Re: G02019763 – Lot 102 Bay Highlands - Variance Request To Whom It May Concern:

BAY HIGHLANDS LOT 102 VARIANCE PLANS

G 02019763

OFFICE OF PLANNING AND ZONING

DEVELOPED CONDITIONS

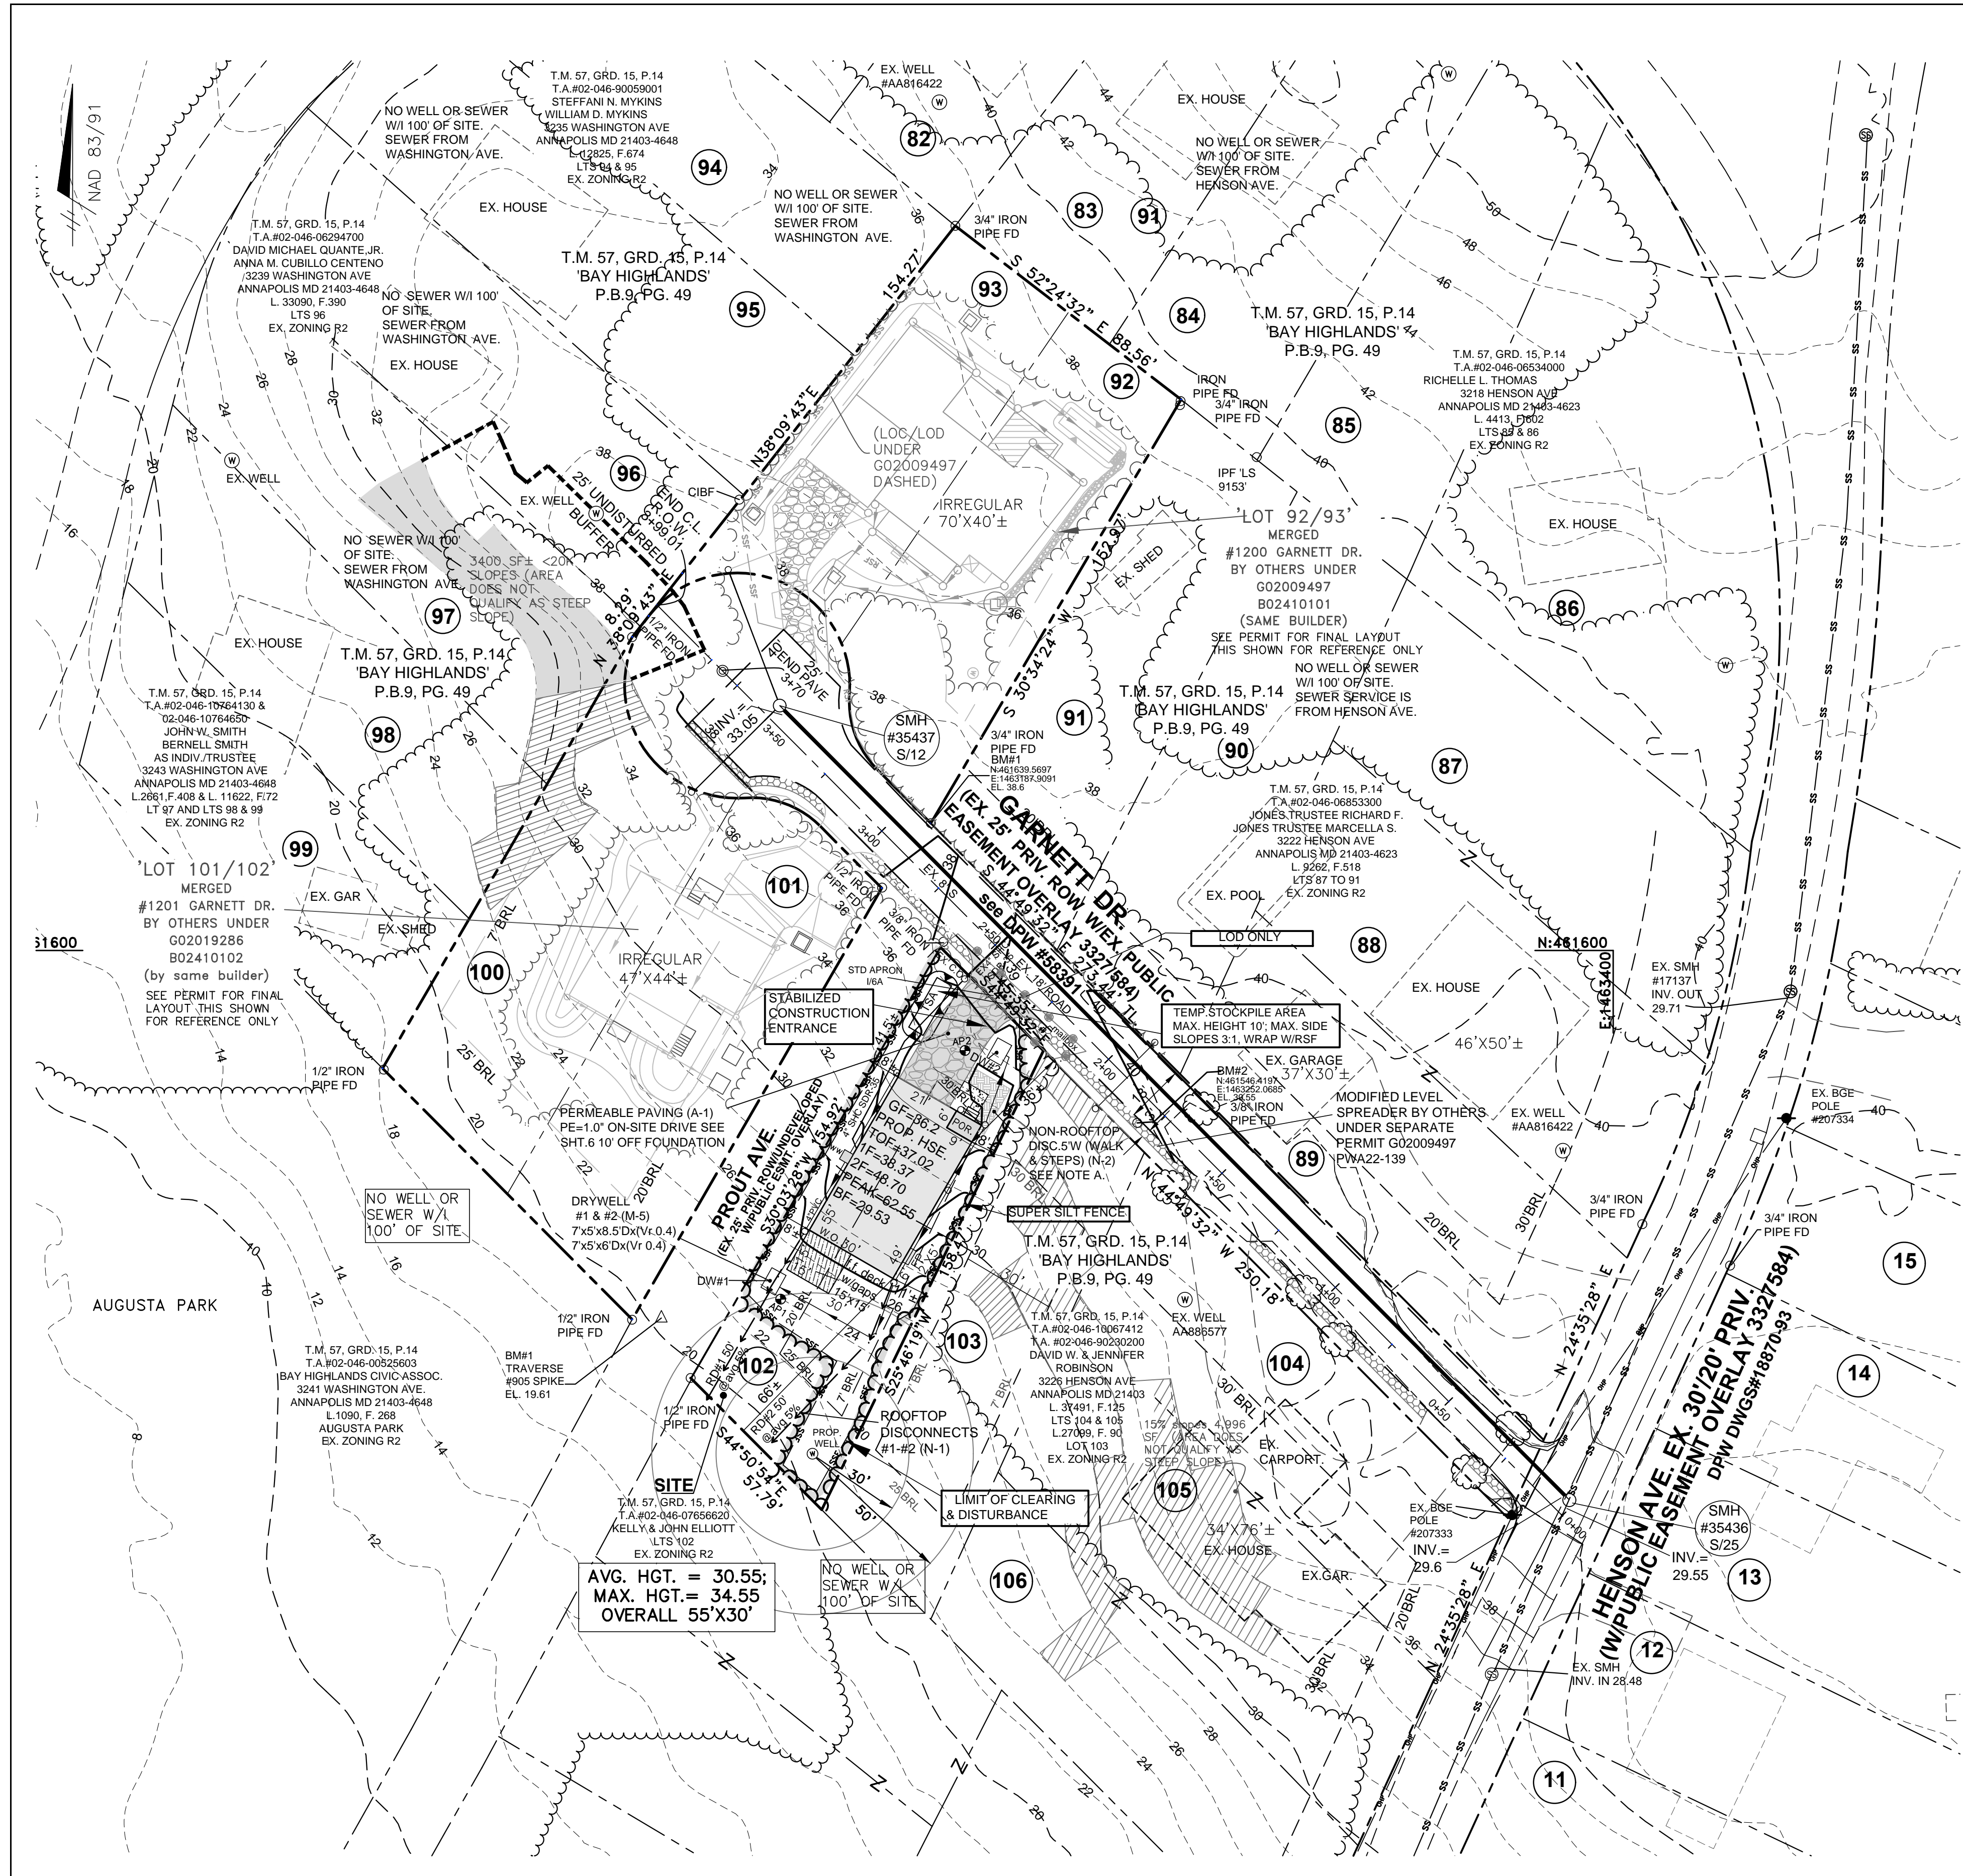
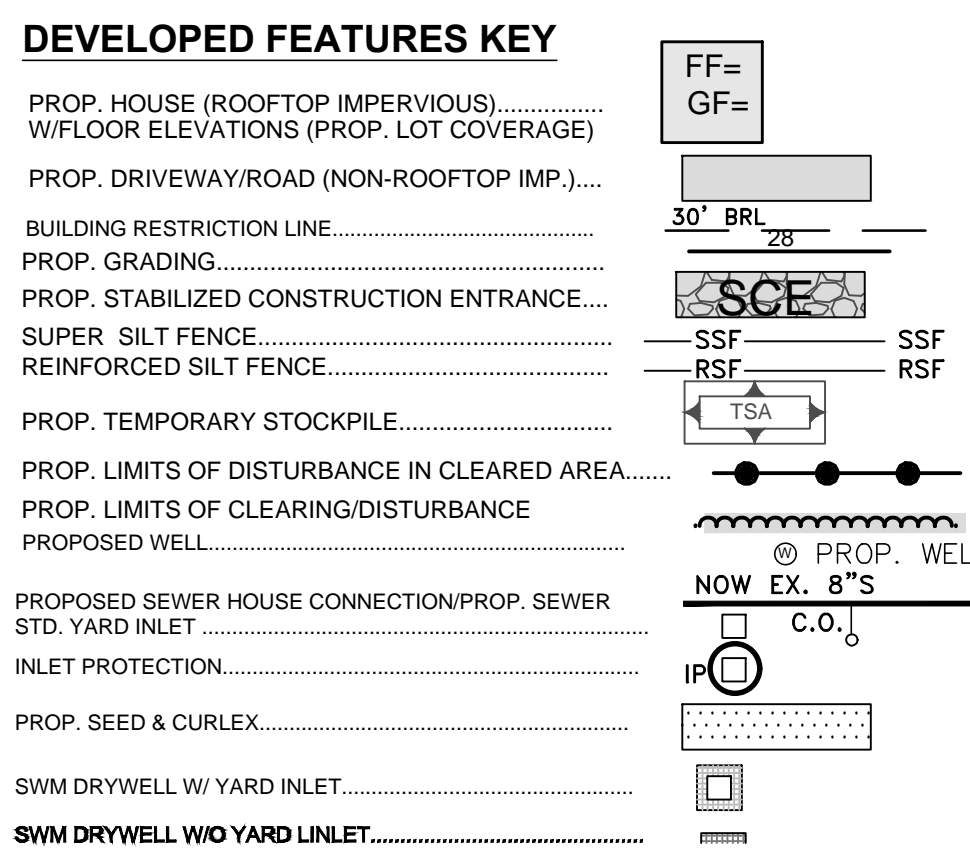
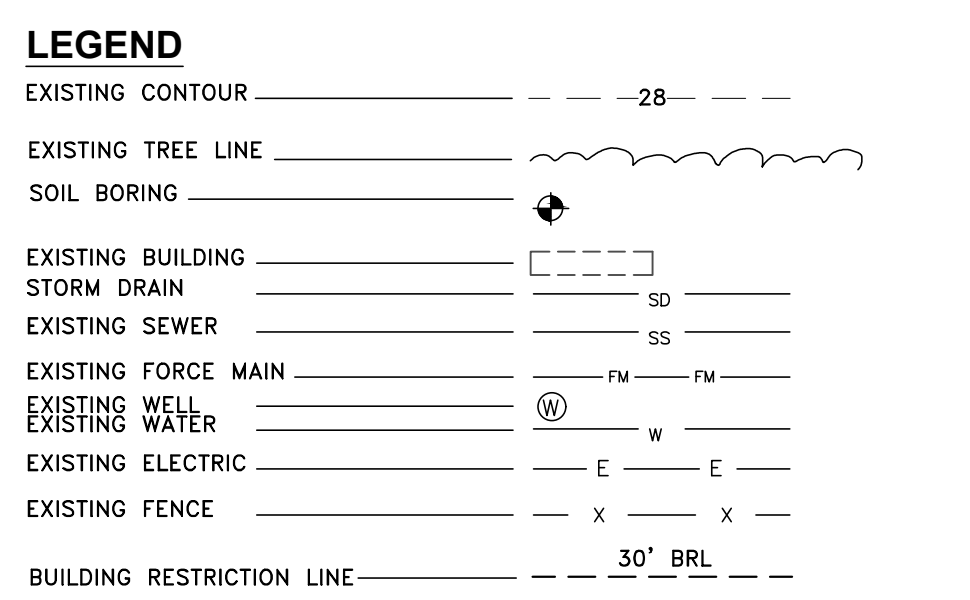
3. Please clarify why a proposed property cannot access from Garnett Drive instead of Prout Avenue. The driveway to the proposed property from Garnett Drive is recommended.

The site plan should be updated to show the correct side corner setback.

- 1) Add the height in stories and feet to the site plan in the area of the proposed dwelling.
- 2) Correct the corner side setback to 20’ per R2 bulk regulations
- 3) Page 2 under General Notes 2. Fix corner side to be 20’ not 25’
